NORTH ANNA POWER STATION

Section 3.3 Instrumentation – Book 2

Improved Technical Specifications

SECTION 3.3 - INSTRUMENTATION
CURRENT TECHNICAL SPECIFICATIONS
MARKUP AND DISCUSSION OF CHANGES

TABLE 3.3-1 (Continued)
REACTOR TRIP SYSTEM INSTRUMENTATION

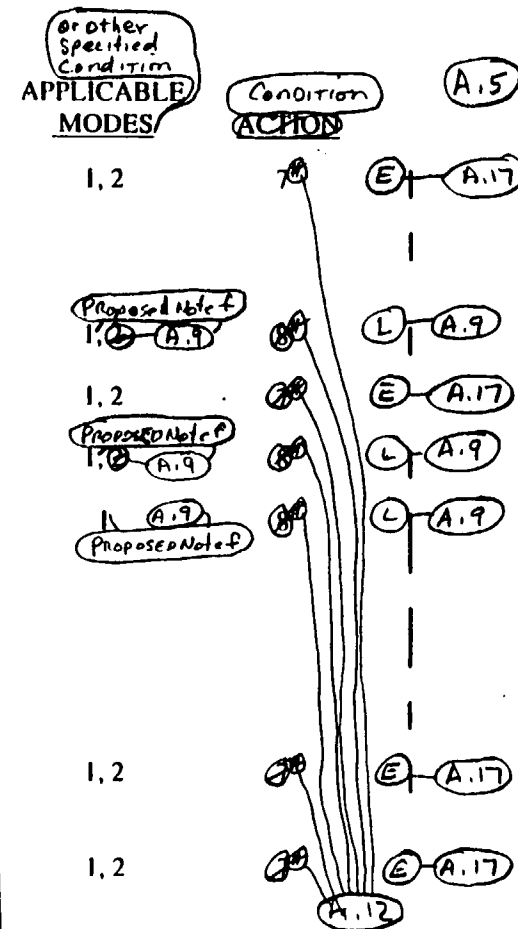
ITS	FUNCTIONAL UNIT	Required TOTAL NO. OF CHANNELS	CHANNELS TO TRIP	MINIMUM CHANNELS OPERABLE
7	8. Overpower ΔT	3	2	2
8a	9. Pressurizer Pressure - Low	3	2	2
8b	10. Pressurizer Pressure - High	3	2	2
9	11. Pressurizer Water Level - High	3	2	2
10	12. Loss of Flow - (Above P-7)	3/loop	2/loop in any loop > P-8 2/loop in any 2 loops > P-7	2/loop in each loop
	13. Deleted			
14	14. Steam Generator Water Level - Low-Low	3/loop	2/loop	2/loop
15	15. Steam/Feedwater Flow Mismatch and Low Steam Generator Water Level	2/loop-level and 2/loop-flow mismatch	1/loop-level coincident with 1/loop-flow mismatch in same loop	1/loop level and 2/loop-flow mismatch-or 2/loop-level and 1/loop-flow mismatch

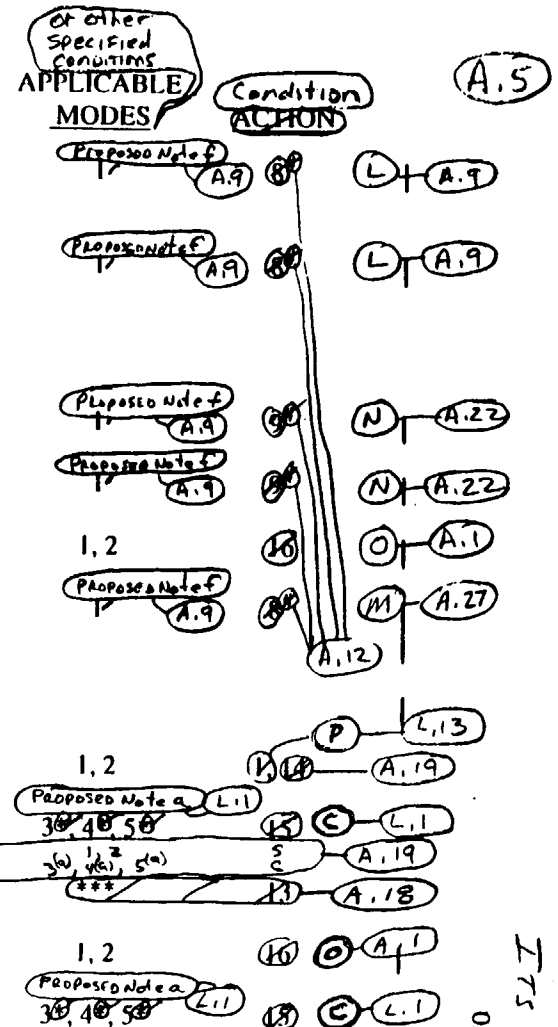
ITS	FUNCTIONAL UNIT	Required TOTAL NO OF CHANNELS	CHANNELS TO TRIP	MINIMUM CHANNELS OPERABLE
12	16. Undervoltage - Reactor Coolant Pump Busses	3 - 1/bus	2	2
13	17. Underfrequency - Reactor Coolant Pump Busses	3 - 1/bus	2	2
16	18. Turbine Trip			
16a	A. Low Auto Stop Oil Pressure	3	2	2
16b	B. Turbine Stop Valve Closure	4	4	3
17	19. Safety Injection Input from ESF	2	1	2
11	20. Reactor Coolant Pump Breaker Position Trip Above P-7	1/breaker	1 > P-8 2 > P-7	1/breaker
19	21. A. Reactor Trip Breakers	2	1	2
20	RTB Undervoltage and Shut Trip Mech.	2	1	2
20	B. Reactor Trip Bypass Breakers	2	1	1
21	22. Automatic Trip Logic	2	1	2
		2	1	2

REACTOR TRIP SYSTEM INSTRUMENTATION

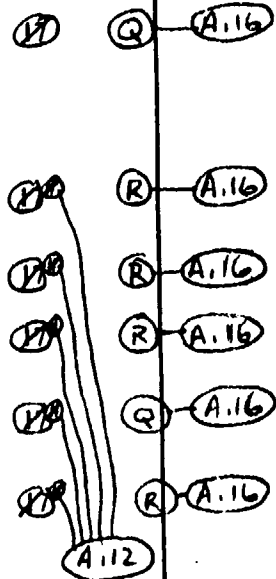
Required TOTAL NO OF CHANNELS	CHANNELS TO TRIP	MINIMUM CHANNELS OPERABLE
2	1	2
4	2	3
2	1	2
4	2	3
4	2	3
2	1	2

1/train
4 A.20
2

- A.20 The requirements in CTS Table 3.3-1 for the Reactor Trip System interlocks list the designated functions as P-7, P-10, and P-13. These interlocks are required to be OPERABLE from the surveillance requirement 4.3.1.1.2, associated with CTS ITS 3.3.1.1. The P-10 and P-13 interlocks are required to provide a signal at a specific indicated power level, from either the neutron detectors (P-10-Power Range Neutron Flux channels), or power indication of the main turbine (P-13-turbine impluse chamber pressure). The P-10 and P-13 function are required to actuate at a specific setpoint with a tolerance up to the allowable value. The P-7 interlock is derived from P-10 and P-13 functions and is a logic function only. ITS 3.3.1, Table 3.3.1-1, list the Reactor Trip System Interlocks as Function 18, and the P-7 function is Function 18d. Function 18d and 18e represent the P-10 and P-13 interlocks. P-10 and P-13 functions are required to actuate and provide its specific interlocks at a specific setpoint with an allowance up to an allowed value. The P-7 Function is not a channel related interlock, but functions on a train related basis. The channel requirements for P-7 are stated as, "1 per train." Because the P-7 interlock is a logic function, there is no setpoint or allowable value limit associated with the function.
